ZONING BOARD OF APPEALS STAFF REPORT May 21, 2020

Area Variance

327-347 Monroe Avenue

Re: Preliminary Site Plan Findings (SP-19-18-19) 327-341 & 347 Monroe Avenue

Proposed Elevations

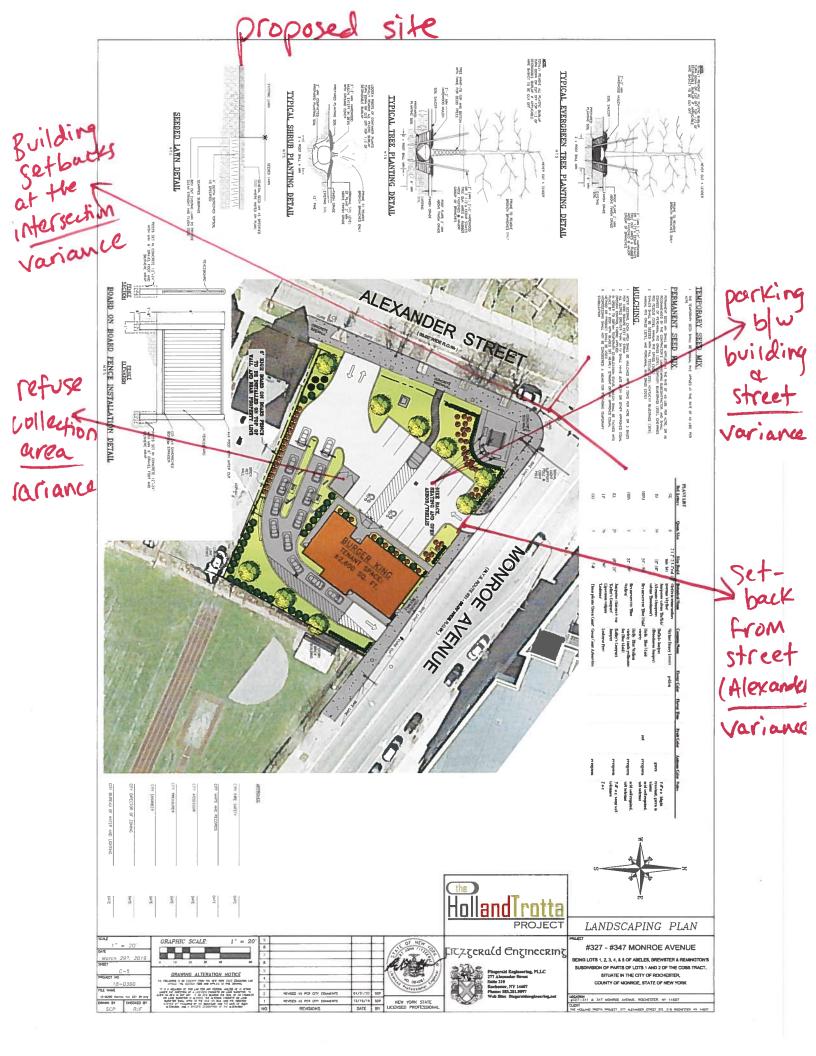
Although the façade rendering provided shows that the rear of the Alexander Street façade will have full transparency into a dining area, the floor plans and elevations drawings show this area will actually be a freezer with no transparency. The applicant proposes display windows to mitigate this. Please note that display windows do not count in the transparency calculation.

The Alexander Street façade of the building has a 24% window transparency. Most new nonresidential construction in C-2 would require 70% transparency between two feet and 8 feet due to the requirement for new buildings to be built up to the street (0ft-5ft), but in this case, the building setback (98ft to 117ft) exempts the building from needing to comply with the transparency requirement. Therefore, if ZBA approves the setbacks, this façade will have no transparency requirement and would be code compliant.
